To: T10 Technical Committee
From: Timothy Hoglund, LSI Logic
Date: 08 May 2006
Subject: SAS-2 BREAK_REPLY

Overview

Figure 32 — Transmit data path in a SAS phy

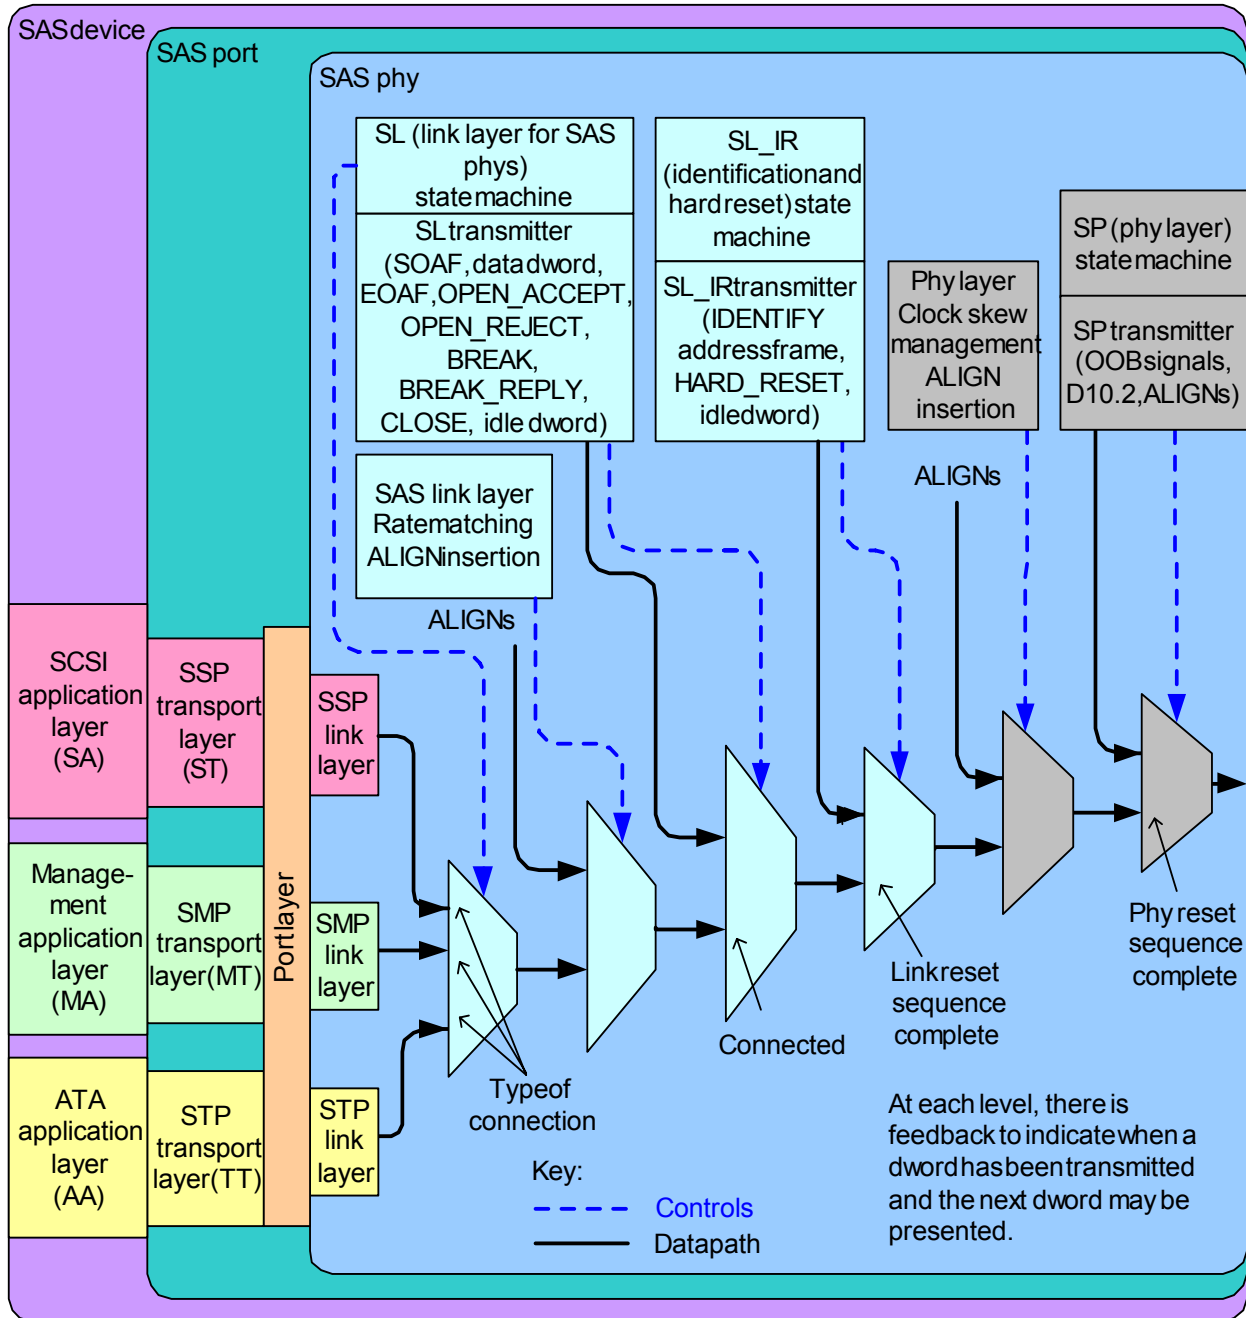
[added BREAK_REPLY to Figure 32]

Figure 36 — Transmit data path and state machines in an expander phy

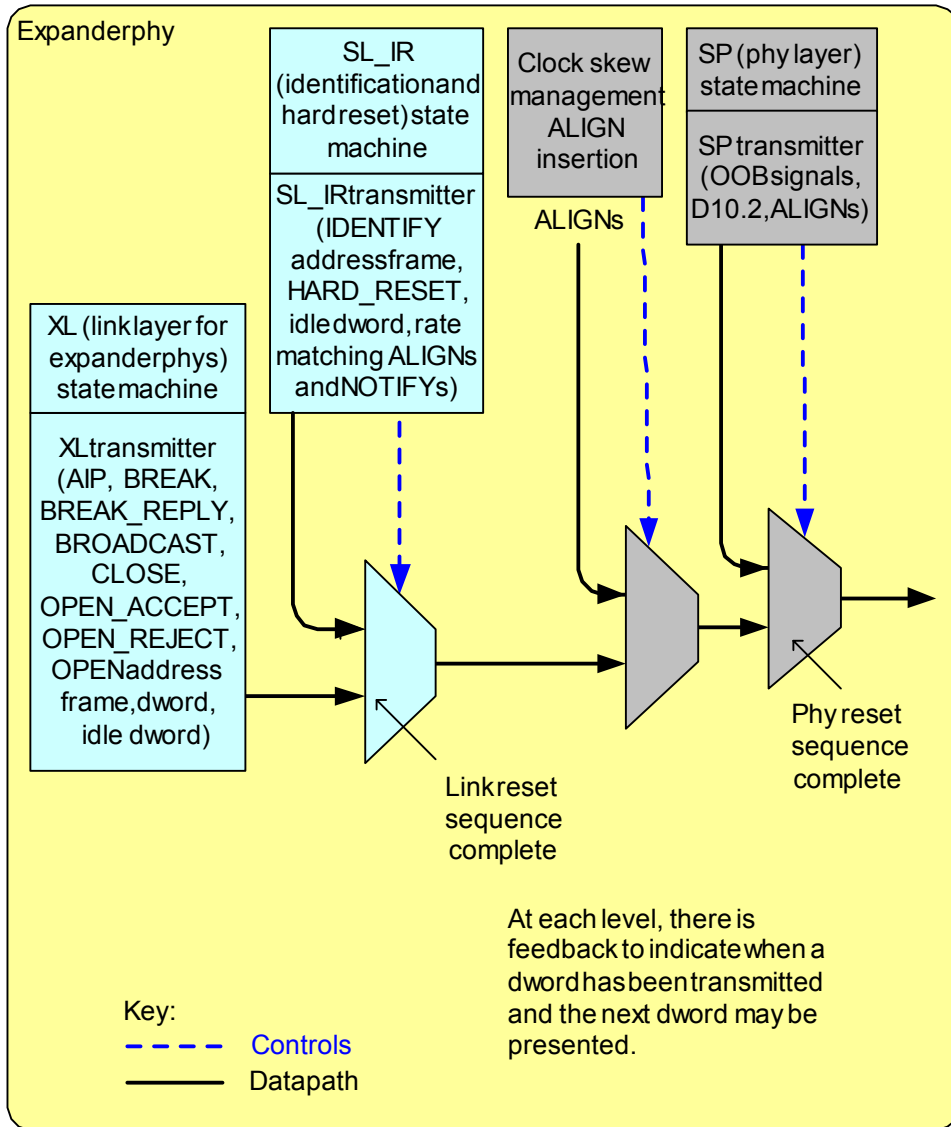
[added BREAK_REPLY to Figure 36]

Figure 142 — Connection request timeout example

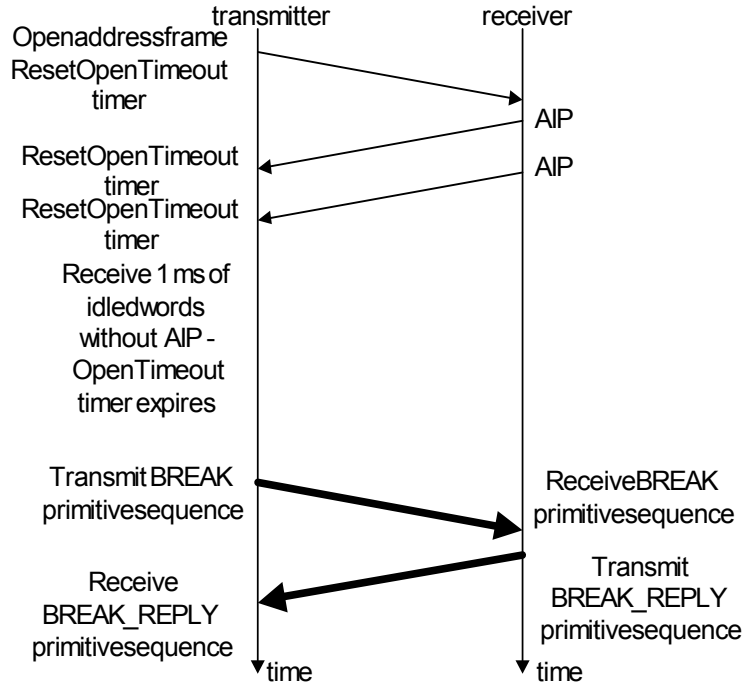
[changed BREAK response to BREAK_REPLY in Figure 142]

NOTE NN - If the BREAK_REPLY method of responding to received BREAK primitive sequences is disabled, then phys transmit BREAK instead of BREAK_REPLY.

Figure 146 — SL (link layer for SAS phys) state machines (part 2)

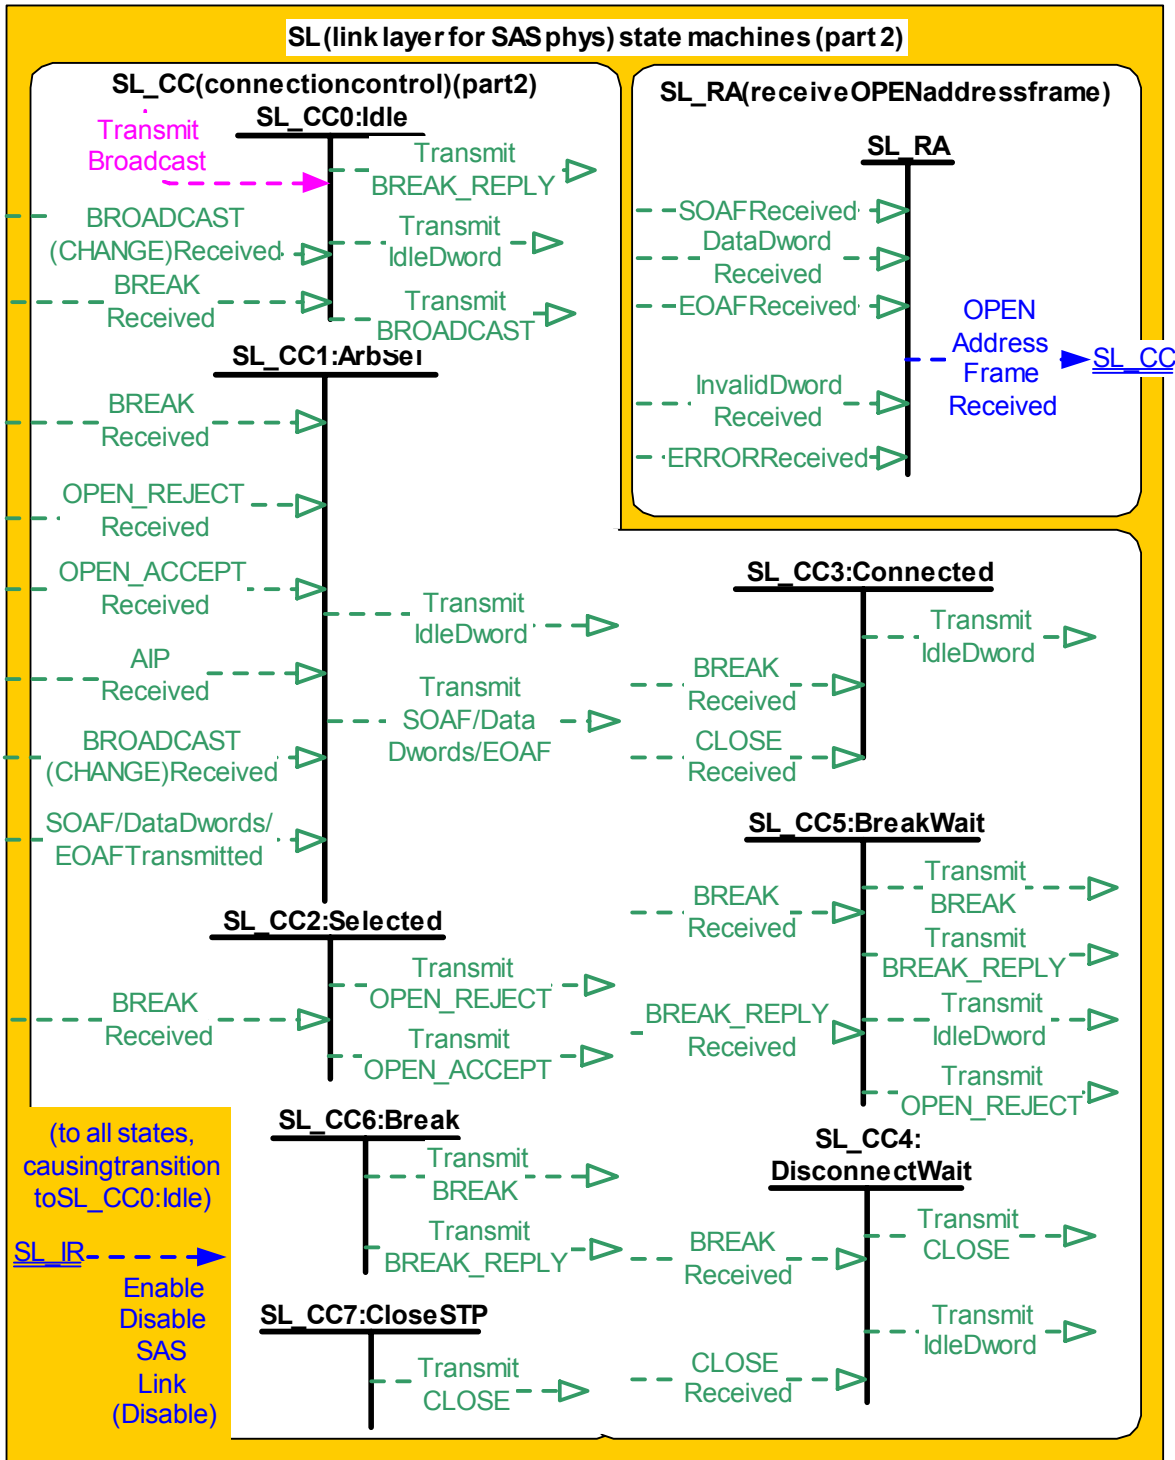
[added Transmit BREAK_REPLY to SL_CC0, SL_CC5, SL_CC6]

[added BREAK_REPLY received to SL_CC5]

[added BREAK Received to SL_CC0]

Figure 147 — XL (link layer for expander phys) state machine (part 1)

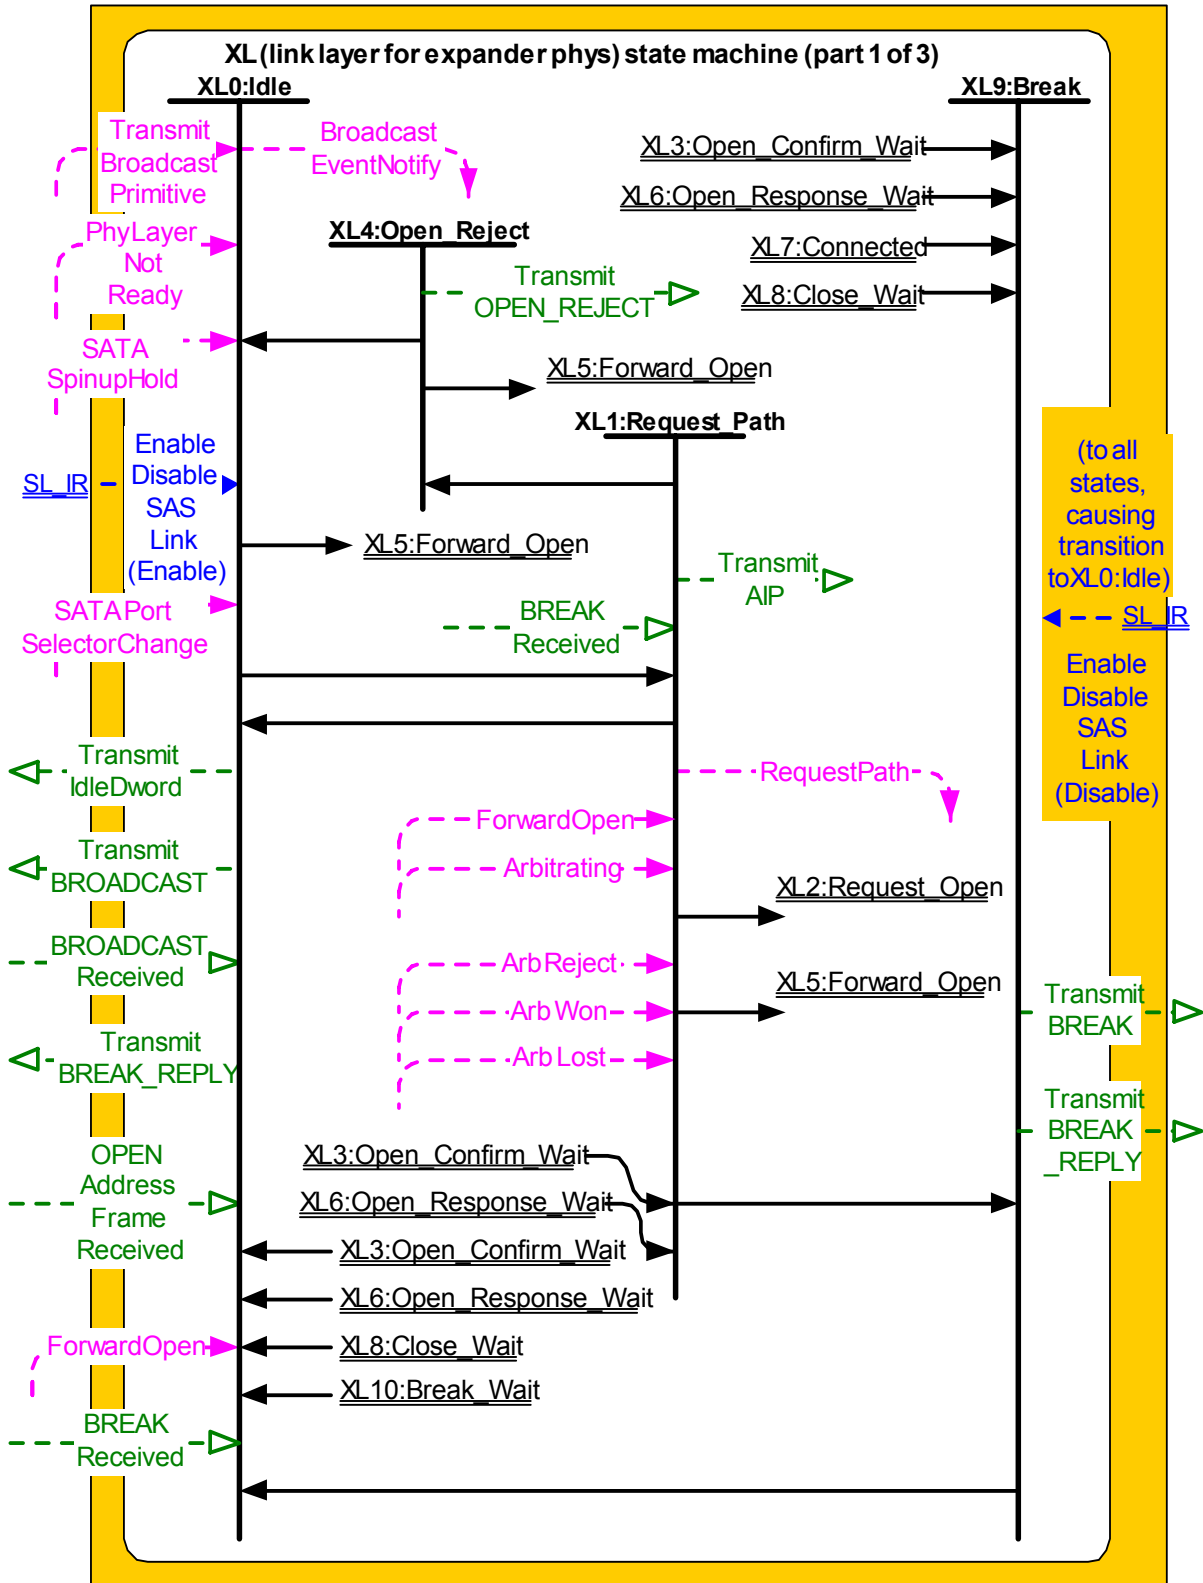
[added Transmit BREAK_REPLY to XL0 and XL9]
 [added BREAK Received to XL0]

Figure 149 — XL (link layer for expander phys) state machine (part 3)

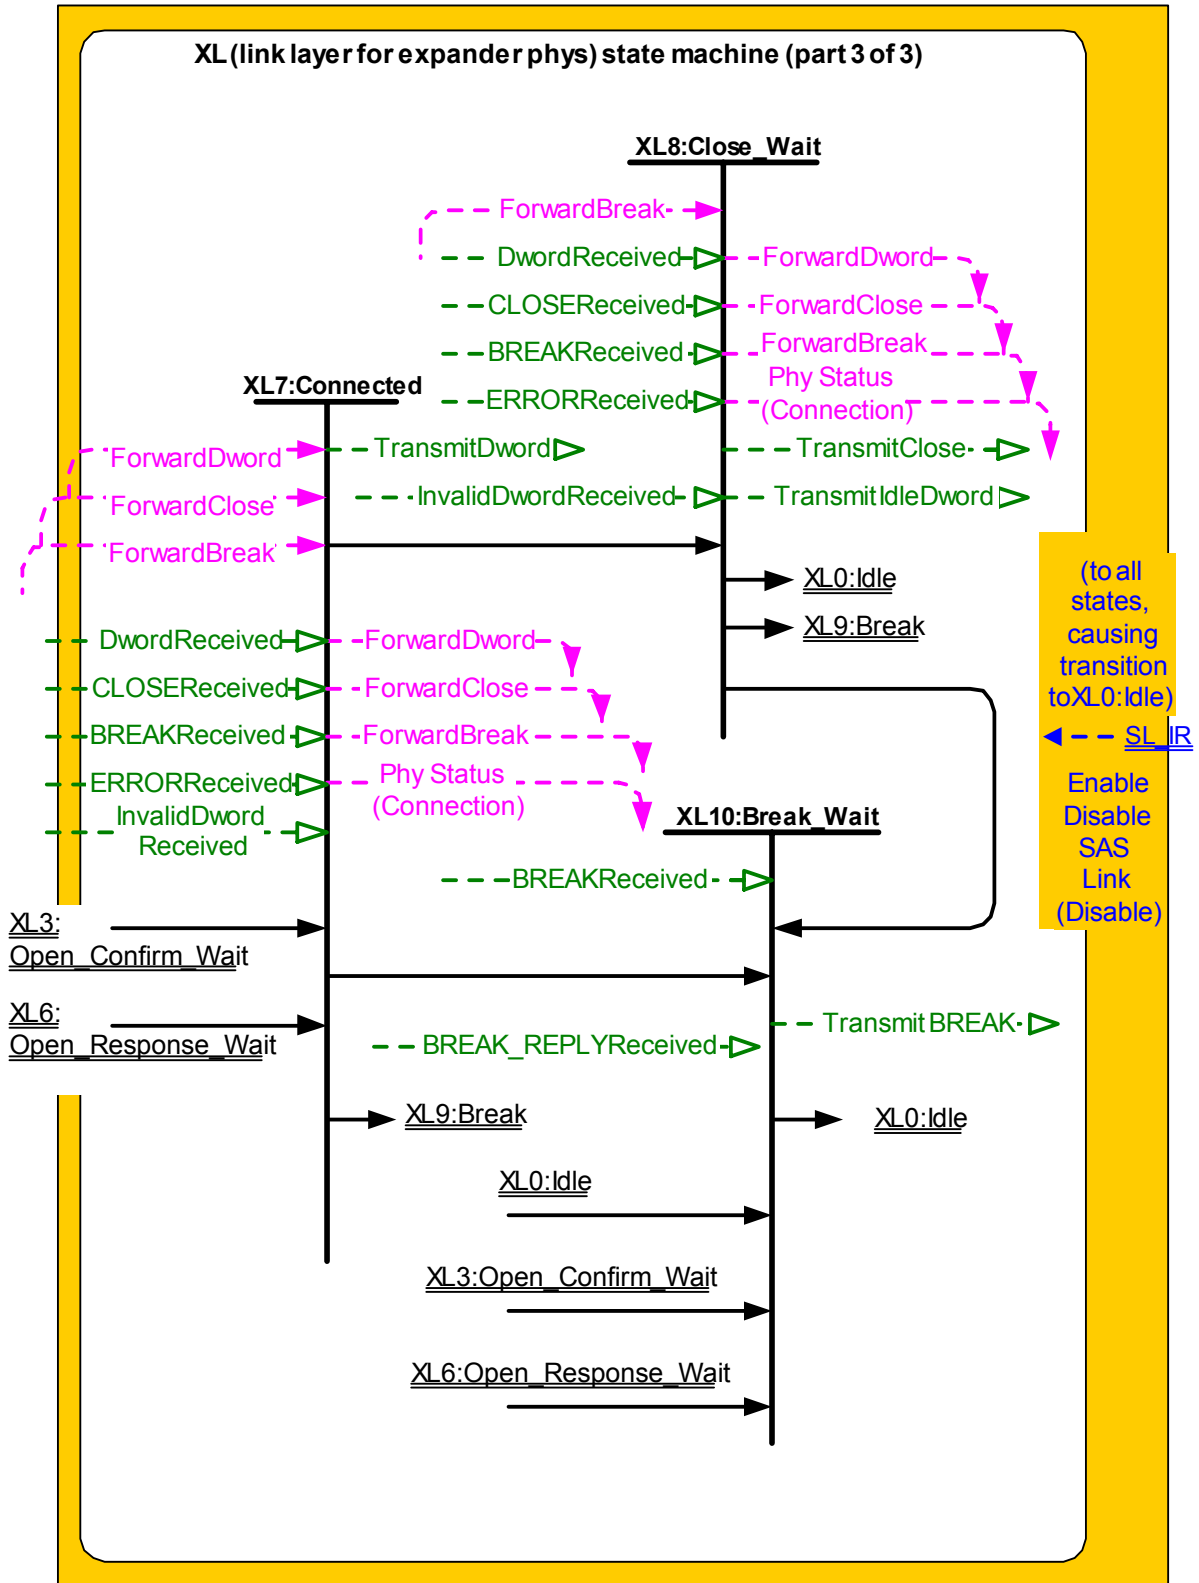
[added BREAK_REPLY Received to XL10]
